Service Notice N°: ESN0074 Rev. 00

Elimination of switch off the working machine or no possibility to turn machine on

Cause: The Y047 board does not work properly.

Y047-1

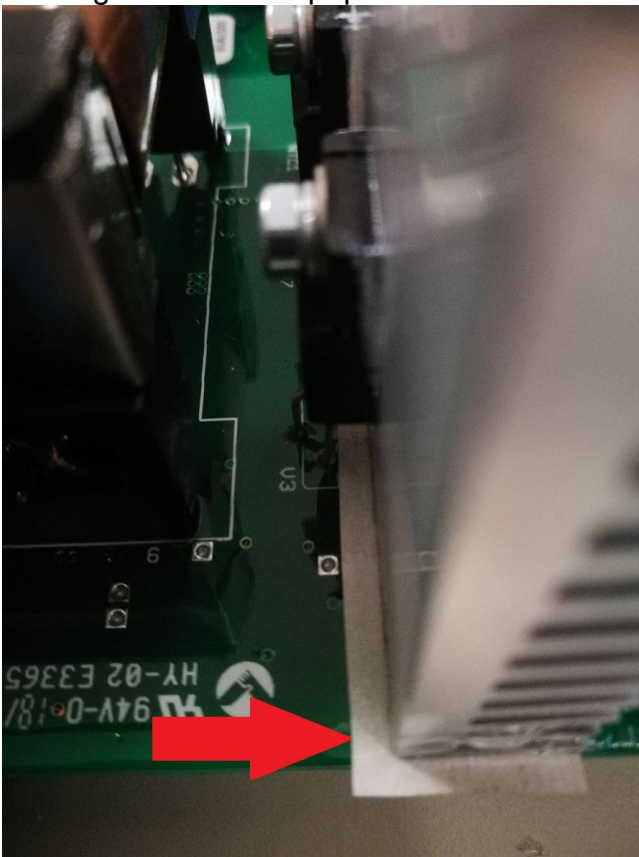
All PTi250C/i320C machines with serial numbers prior to those listed above are susceptible to this problem. Machine that will be modified will have the Y047 supply board (index: R-6042-081-1) assembled **without** additional element showed on the pictures below:

Check absence of component placed in red rectangle:

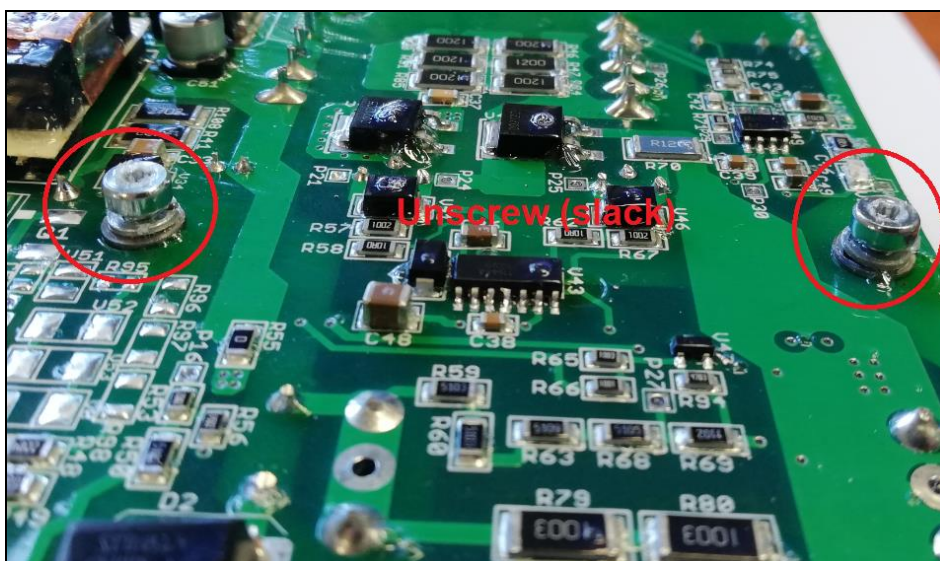
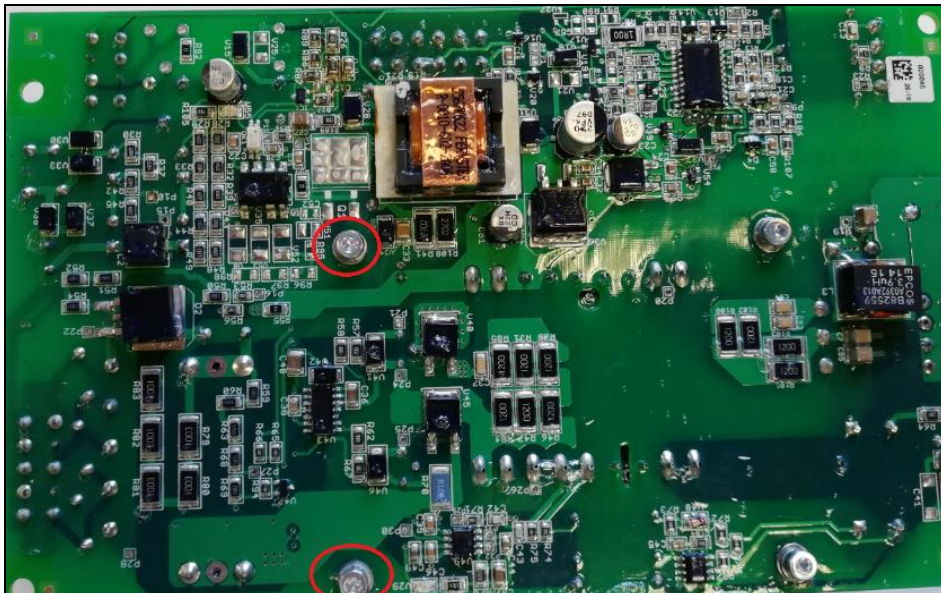
Missing an insulation paper under H1 heatsink:

The elimination of this problem can be achieved by ordering and replacing the Y047 board with a proper one. Now, all boards available on the stock are already modified to avoid described problem.

The right PC boards numbers to order is:

R-6042-081-1R

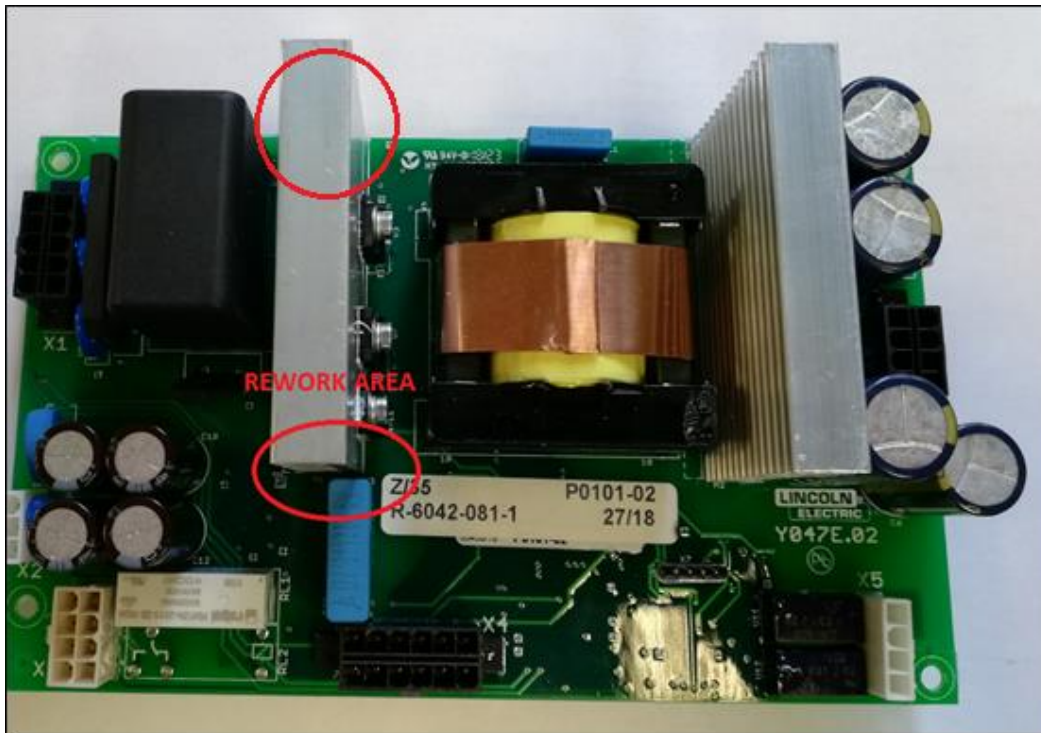
1. Unscrew (slack) 2 screws that were used to assembled H1 heatsink:

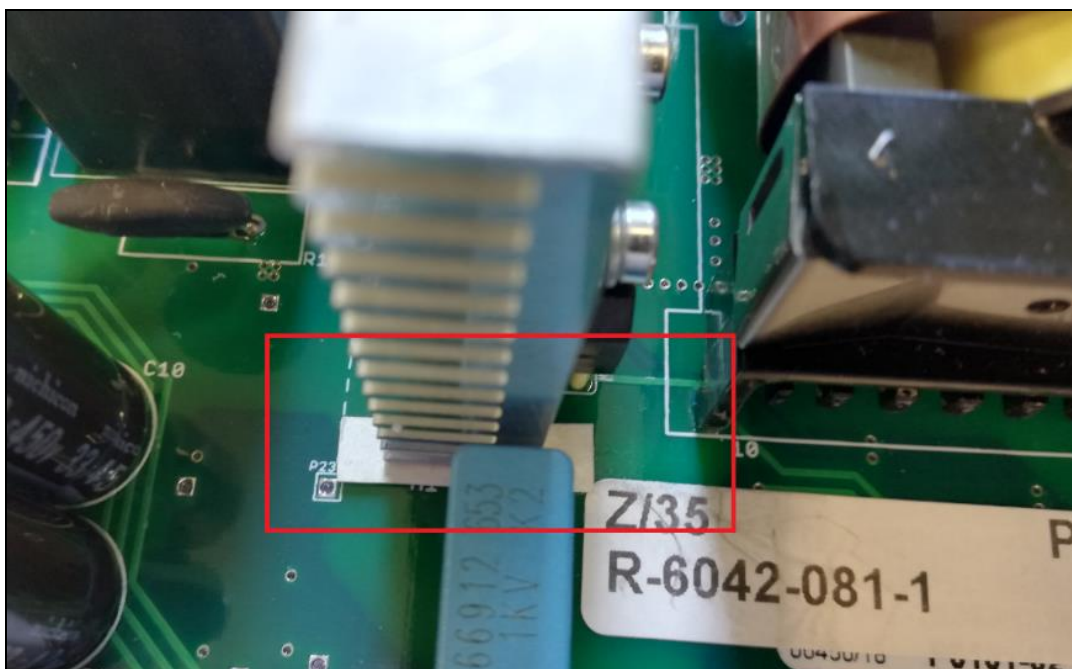
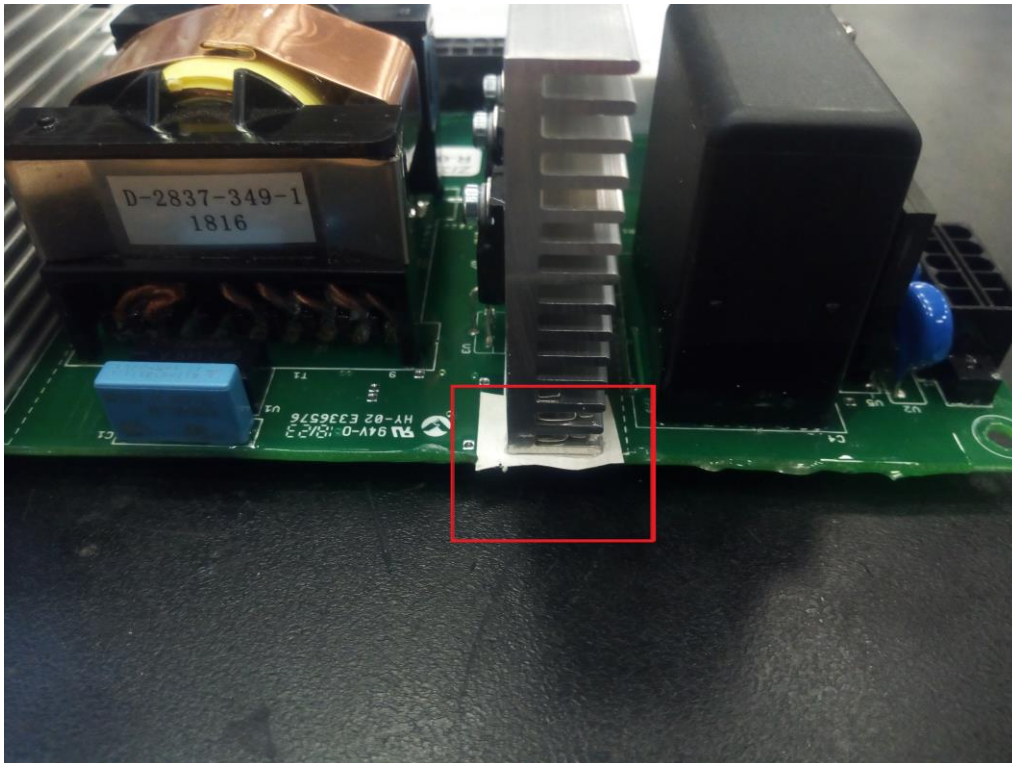
2. Find rework area:

3. Uplift H1 heatsink slightly with a flat screwdriver – heatsink will tilt to right side (to transformer T1).

4. Place two pieces of insulation paper (c.a. Nomex, index NNX0830250 20x5mm, 0,25-0,3mm thickness) under both side of H1 heatsink as is shown on the pictures below:

5. Tighten 2 screws to H1 heatsink:
